PLANNING COMMISSION AGENDA
August 8, 2023 – 5:30 PM

Memo Date: August 1, 2023
Meeting Date: August 8, 2023
To: Newport Planning Commission
From: Nathan Fuerst, AICP, City Planner
Subject: Preliminary & Final Plat and PUD Review – Red Rock Square II

Subject: Red Rock Square II – Plan Review

C2.1

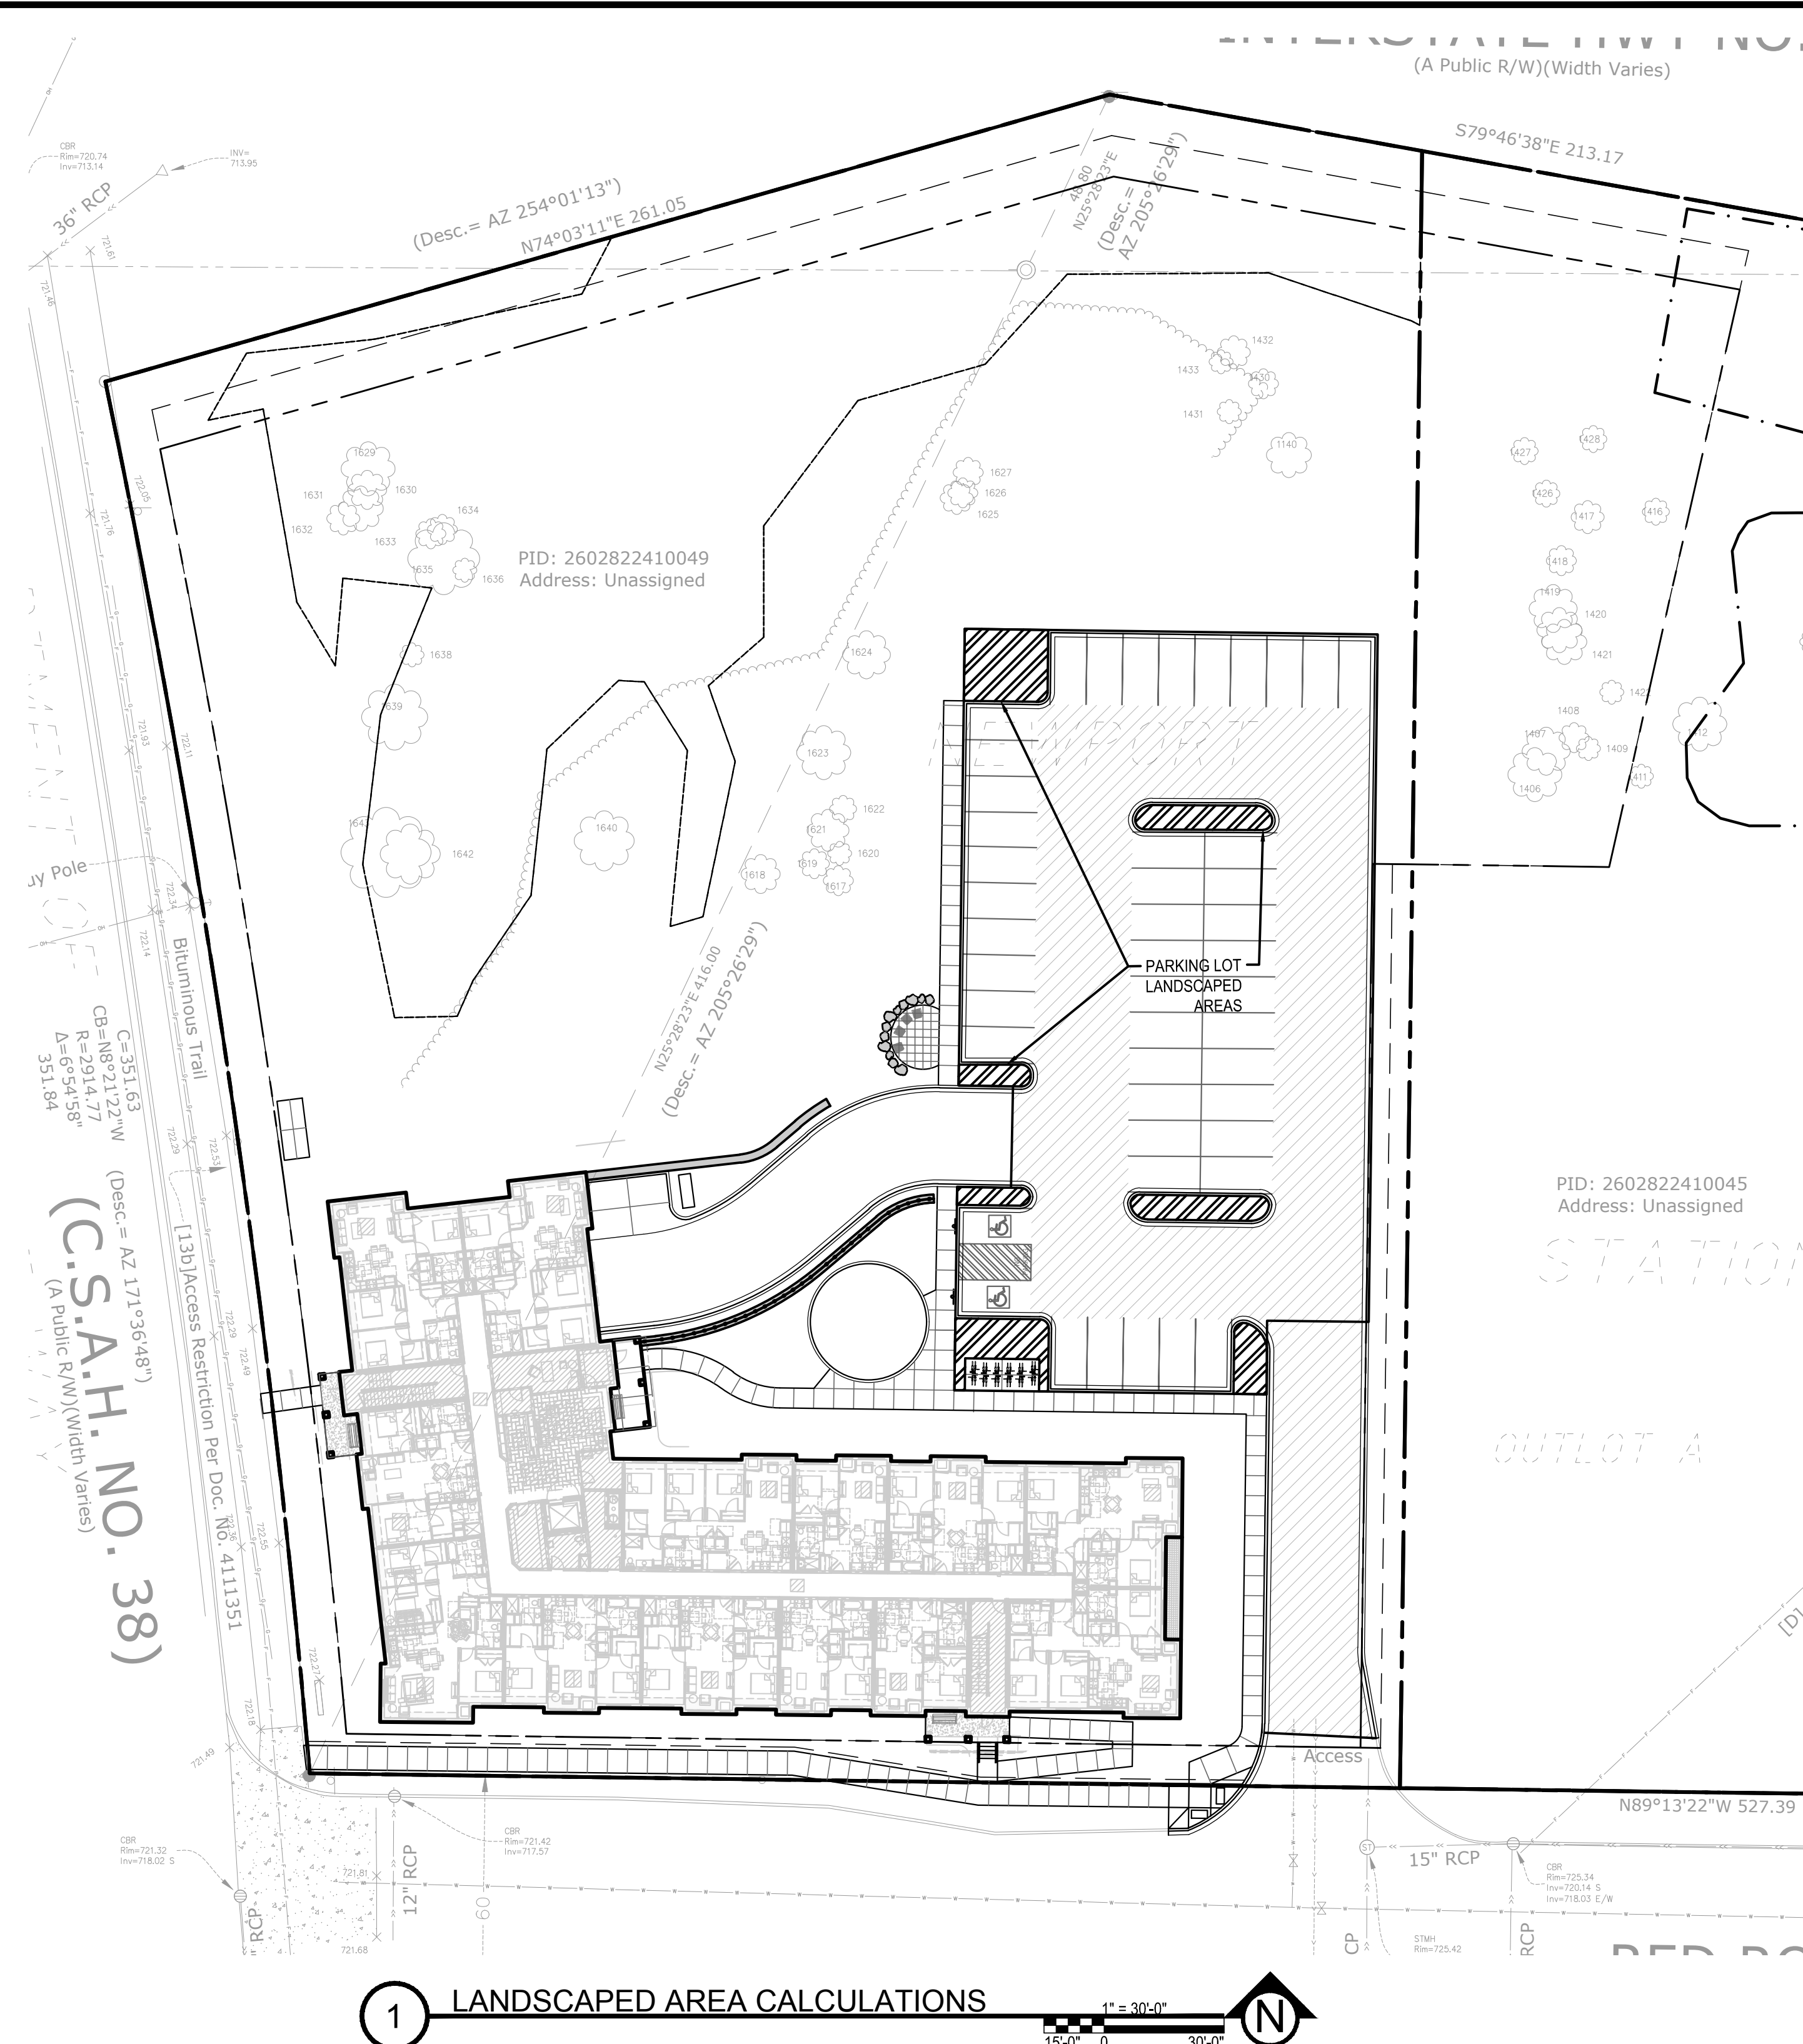
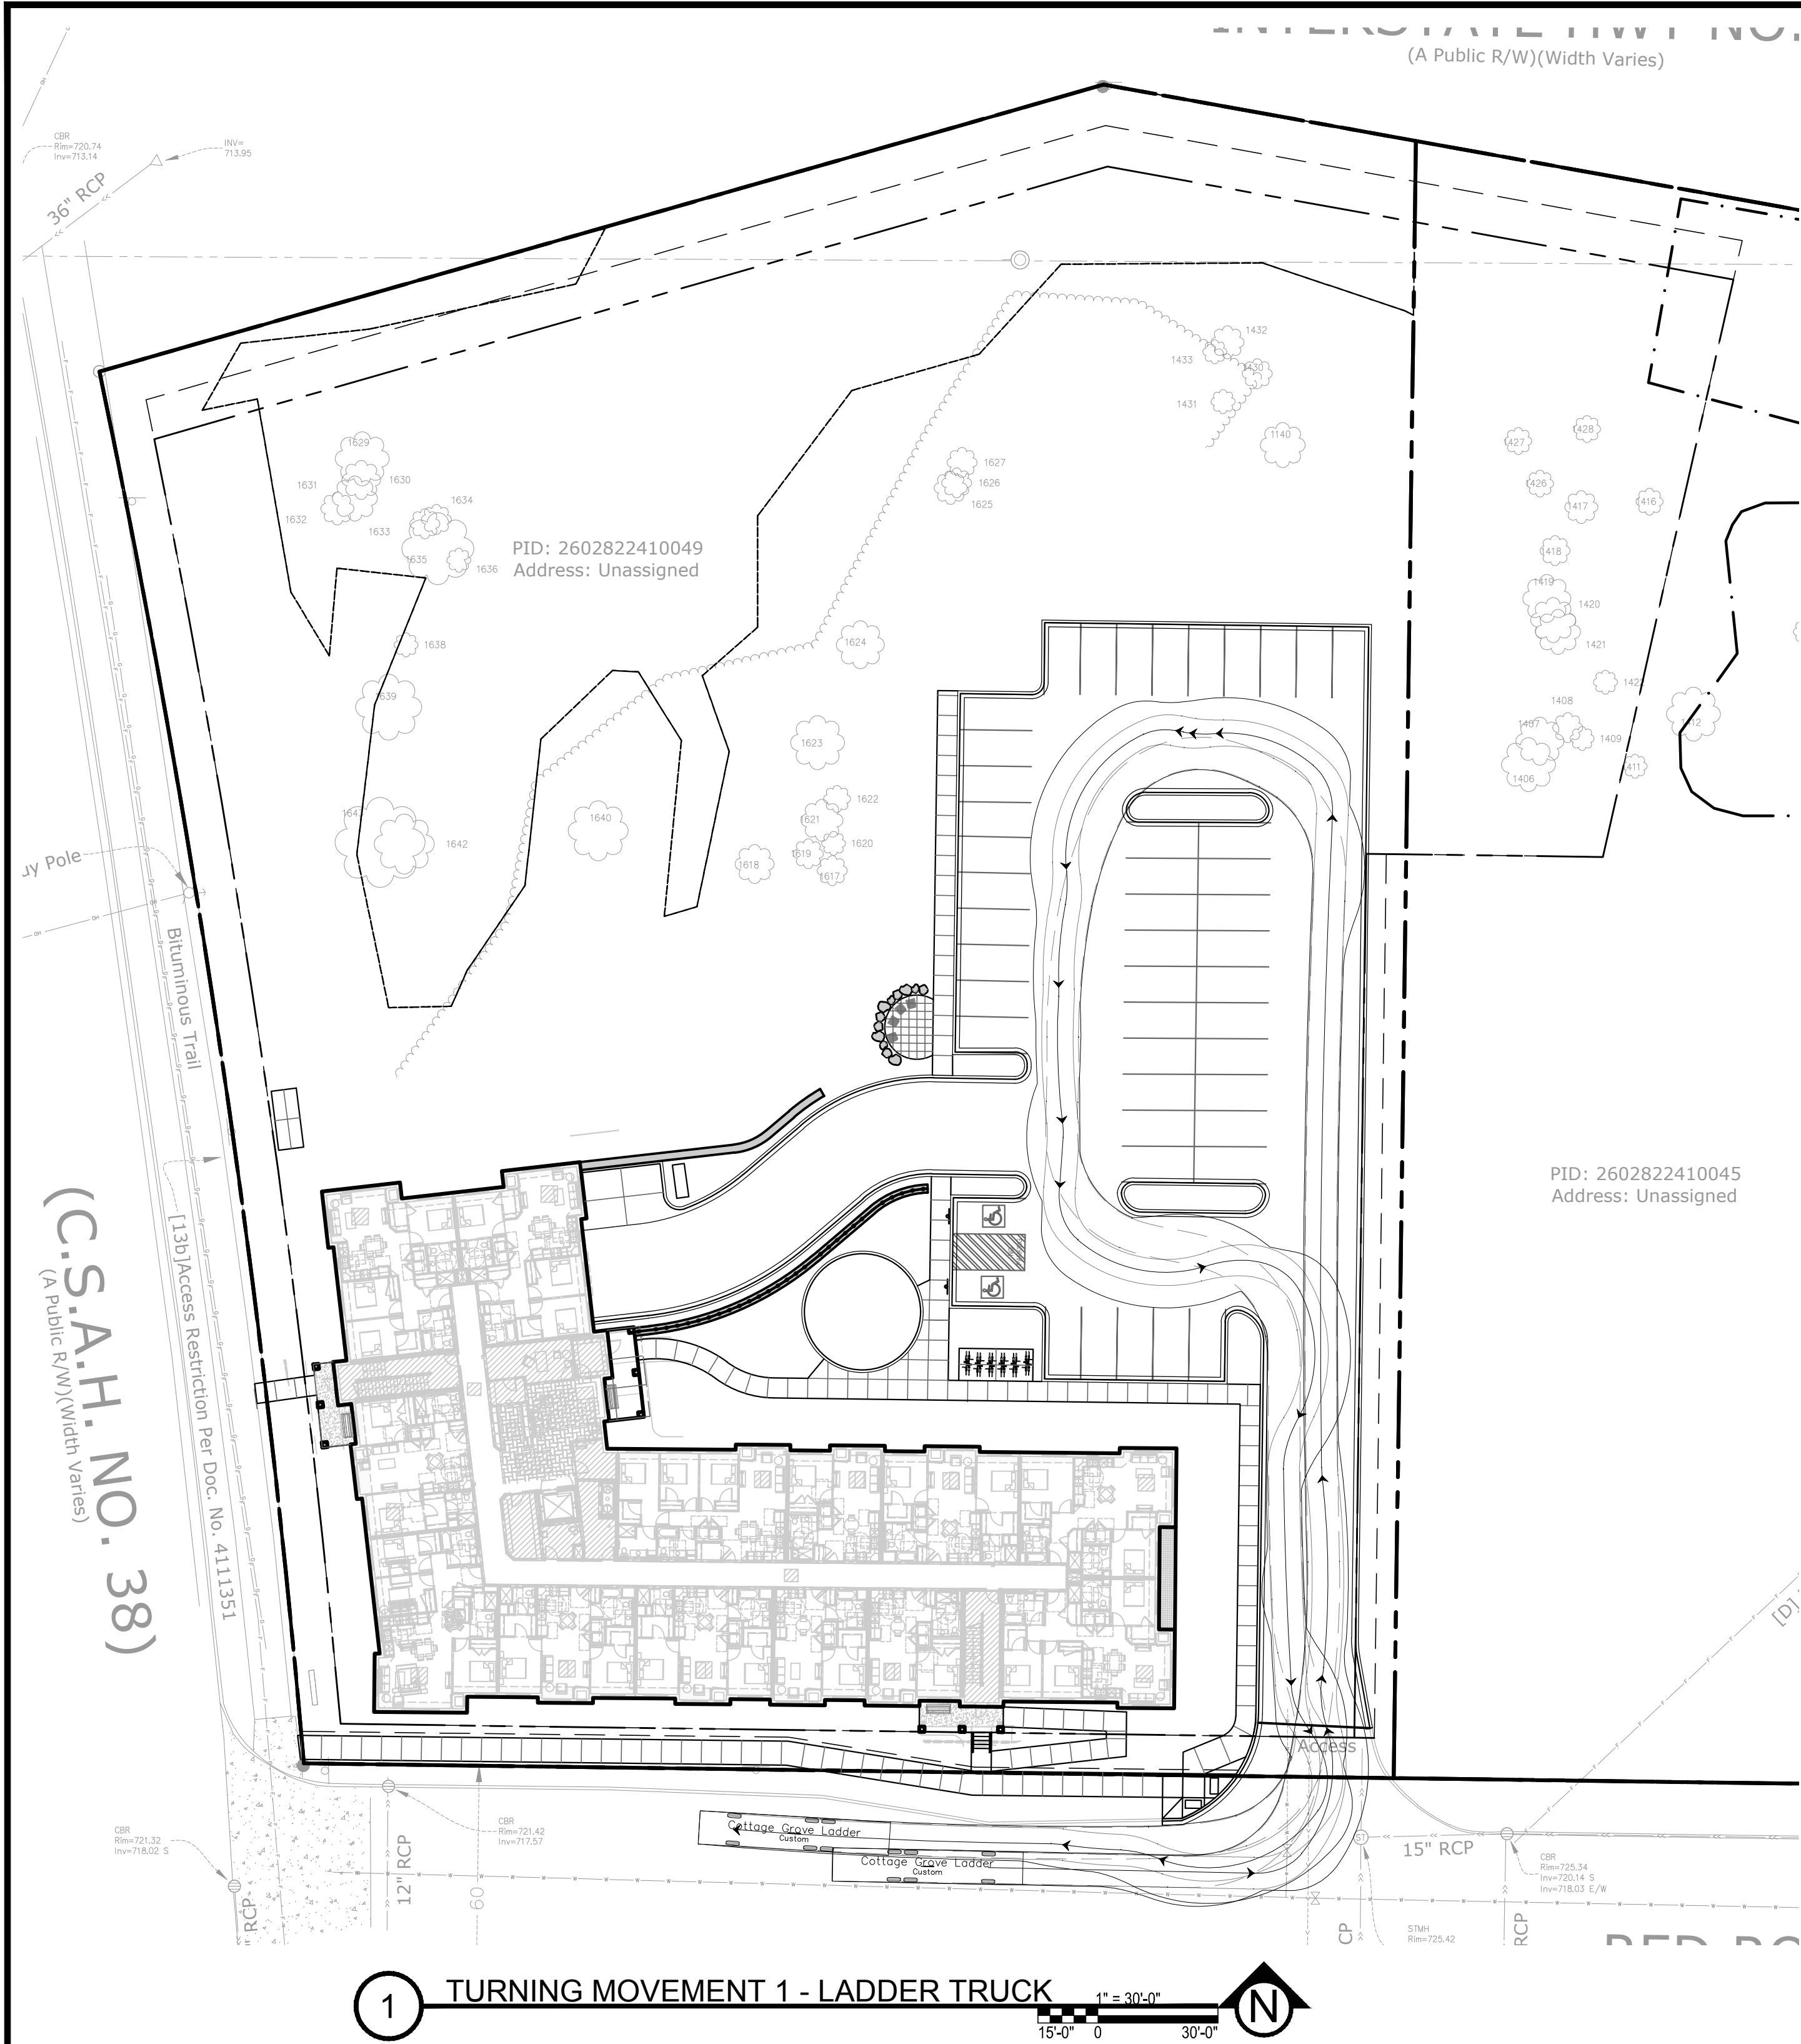
- Parking Lot Landscaping – City Code requires that parking lots serving over eight vehicles provide 10% of the area as landscaping. The Developer is proposing to landscape only 7% of this area due to the need to accommodate the sizable wetland on site. Given that the landscaping areas proposed provide adequate landscaping, and that the parking lot area is reduced to accommodate a large wetland, staff are supportive of this request.
